### GR-4 Noise

Comments received on Chapter 2.6, Noise, of the Campo Wind Project with Boulder Brush Facilities (Project) Draft Environmental Impact Report (EIR), the Acoustical Analysis Report prepared by Dudek (Appendix G to the Draft EIR), and the addendum to the acoustical report (Appendix G) can largely be organized into the following categories:

**Figure GR-4-A.** Hypothetical scenario: sound level meter positioned near a residence, which features an air-conditioning unit

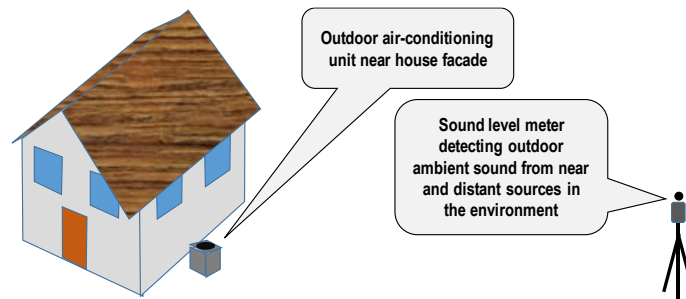
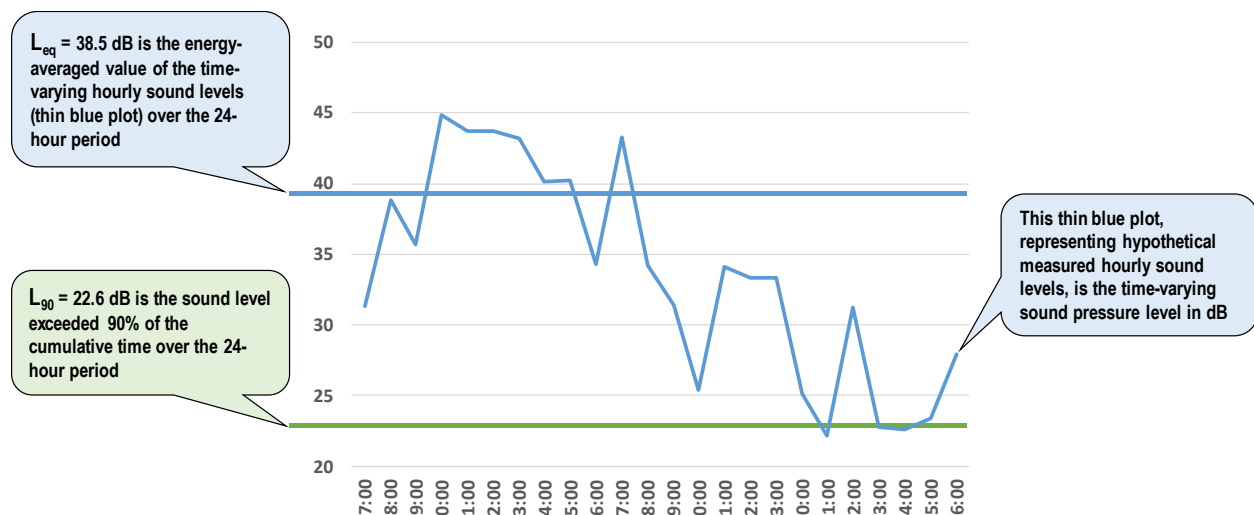
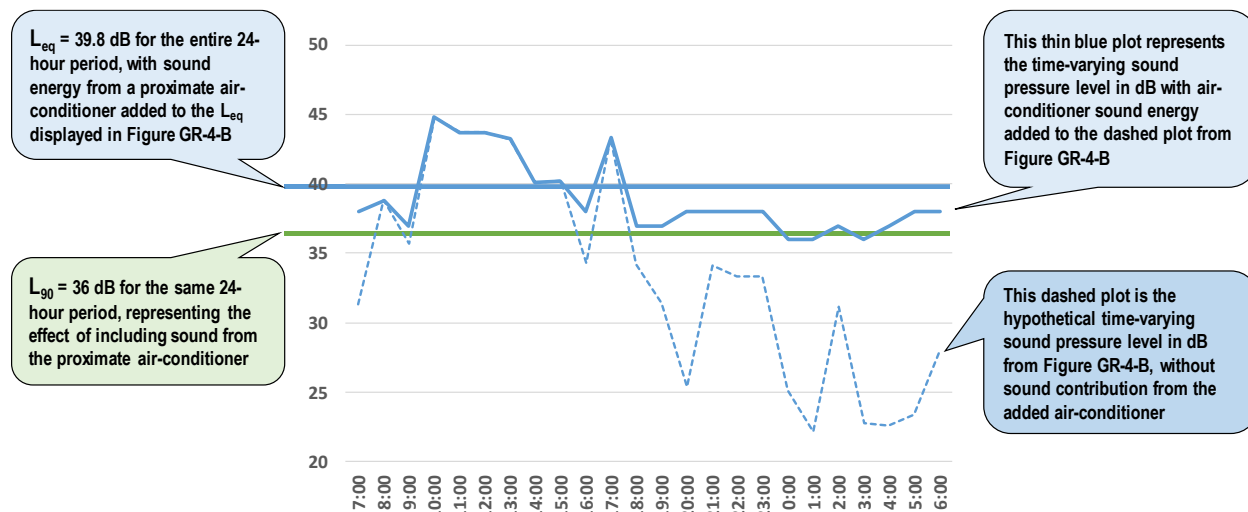
Commenters also stated that the noise measuring instruments should have been placed closer to residences to be more representative of ambient conditions. Because  $L_{90}$  is a statistical value that shows what sound pressure level (SPL) over a given time period is exceeded 90% of the time, it is sensitive to nearby continuous sources of noise such as operating air-conditioners, generators, pump motors, or other powered appliances located at or near an occupied residential land use. To help illustrate this sensitivity, a generic sample scenario (i.e., not to be construed as an actual survey sample associated with this Project) is shown in Figures GR-4-A, GR-4-B, and GR-4-C. These figures show a hypothetical example of how placement of a sound level meter near a typical residential use which has a continuously operating air conditioner can skew the results of ambient outdoor noise measurements upwards.

Figure GR-4-B shows the outdoor hourly sound level for a hypothetical scenario in which a residence’s air conditioner is not operating, while Figure GR-4-B shows the sound levels for a scenario with the air conditioner operating. The sound levels plotted in Figure GR-4-C illustrate what would happen if the measurement position is placed near a hypothetical residence’s air conditioner, or another continuous or “steady-state” source of noise. With the air conditioner operating, the  $L_{90}$  value rises substantially and thus risks not being representative of the outdoor ambient environment. Consistent with this reasoning, Dudek 2018 and 2019 field survey positions were selected to be on publicly accessible land or on the borders of occupied properties so that the collected  $L_{90}$  values represent the amalgam of all outdoor sound contributors and are not skewed upwards by continuous noise sources typical of residential uses.

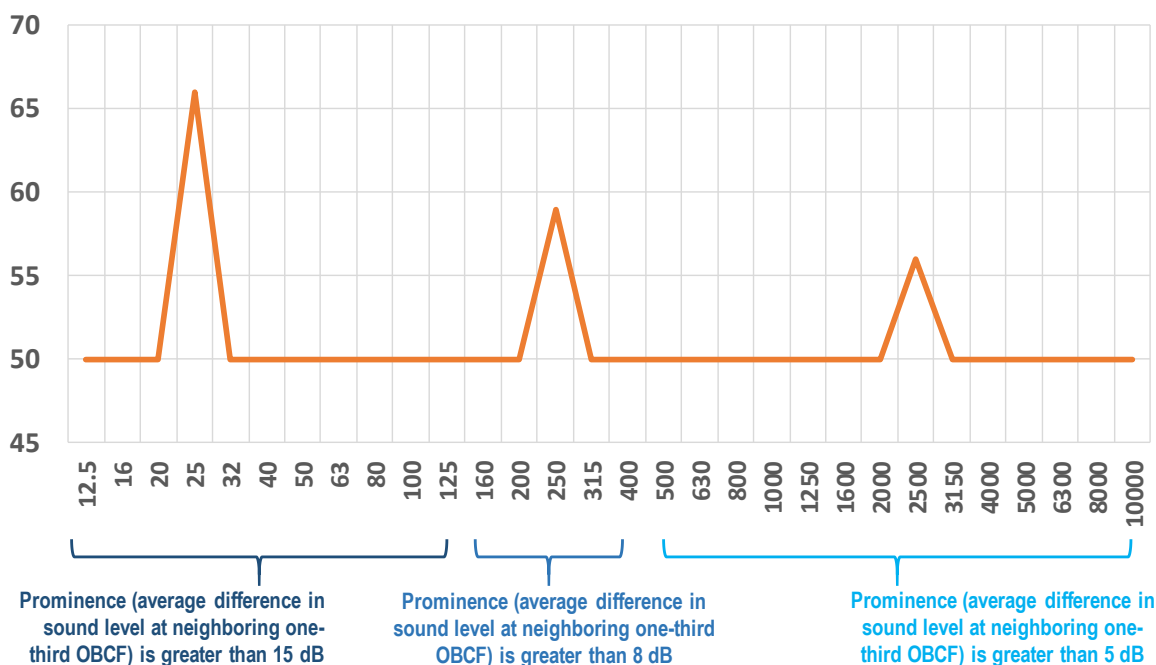
3. The anticipated Project wind turbine operation noise would not feature characteristics that would meet the conditions for a “pure tone” as defined by Section 6952.f.3 of the County’s Zoning Ordinance. Figure GR-4-D presents three examples of what such pure tones might look like if plotted, per the Ordinance 10262 Section 6952.f.3 language as follows:

A ‘pure tone’ exists if one-third of the octave band sound pressure level in the band, including the tone, exceeds the arithmetic average of sound pressure levels of the two contiguous one-third octave bands by five dBA for center frequencies of 500 Hz or more, by eight dBA for center frequencies between 160 Hz and 400 Hz, or by 15 dBA for center frequencies less than or equal to 125 Hz.

**Figure GR-4-E.** A-weighted curves of sample predicted wind turbine operation noise, at one-third octave band center frequency (OBCF) spectral resolution, for various distances from the wind turbine

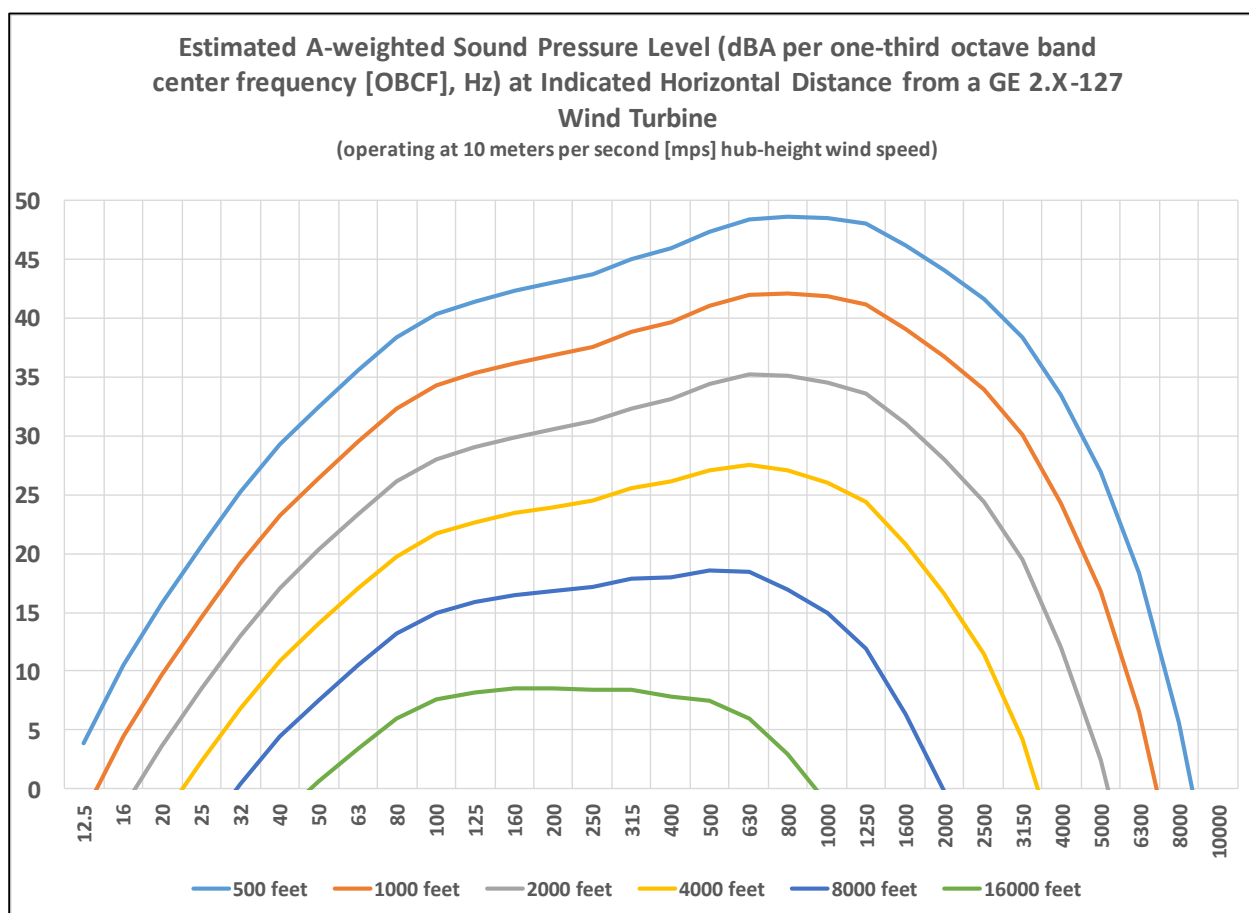
- the wind turbine model used as a source of reference sound power data was considered inappropriate
- potential under-prediction of impacts due to model accuracy
- the lack of one-third octave band detail to help assess “pure tone” conditions
- a lack of clarity regarding where and when potential noise impacts may occur

Using available one-third octave band center frequency (OBCF)<sup>6</sup> resolution data for the aforementioned GE 2.X-127 model, Figure GR-4-E displays plots of predicted A-weighted SPL at various distances between this sample wind turbine and a residence. The calculation accounts for both distance and frequency-dependent atmospheric absorption (i.e., air attenuates sound more readily at higher frequencies). Any attenuation due to ground effects are conservatively ignored. None of the plotted SPL appearing in Figure GR-4-E feature instances of peaks or prominence that resemble pure tones as defined by Ordinance 10262 and shown in Figure GR-4-D. Instead, the plots appearing in Figure GR-4-E are smooth curves, indicating that pure tone criteria per the County's definition are not satisfied.

The prediction method used to generate the SPL plots in Figure GR-4-E assumes an operating wind turbine receives wind at hub height with an average velocity of 10 mps, which represents the loudest noise emission for the operating wind turbine. Using the same prediction method, and for the same presented sample wind turbine-to-receptor distances as appearing in Figure GR-4-E, predicted SPL from the turbine operating under conditions of lower received average wind velocities (e.g., ranging from 4 mps to 9 mps) also do not exhibit pure tone conditions. These

findings, including the plots displayed in Figure GR-4-E, provide support for the County's conclusion that pure tone conditions are not expected to occur; thus, the County noise criteria in Section 36.404 would not need to be reduced by 5 dBA, and the thresholds discussed in the Draft EIR are accurate as-is and properly reflect County hourly  $L_{eq}$  requirements.

The prediction method used to plot the SPL shown in Figure GR-4-E was also used to conservatively assesses the concurrent operational noise level at a single residence from as many as six operating wind turbines (receiving hub height average wind speed at 10 mps) at a variety of sample distances displayed in Figure GR-4-E: three at a distance of 1,000 feet, one at 2,000 feet, one at 4,000 feet, and one at 8,000 feet. For this and many other studied hypothetical scenarios of multiple operating wind turbines at different distances from a common receptor, pure tone conditions do not arise. This non-tonal acoustical feature predicted for the GE 2.X-127 model wind turbine would also be expected for other wind turbine models commercially available and under consideration.
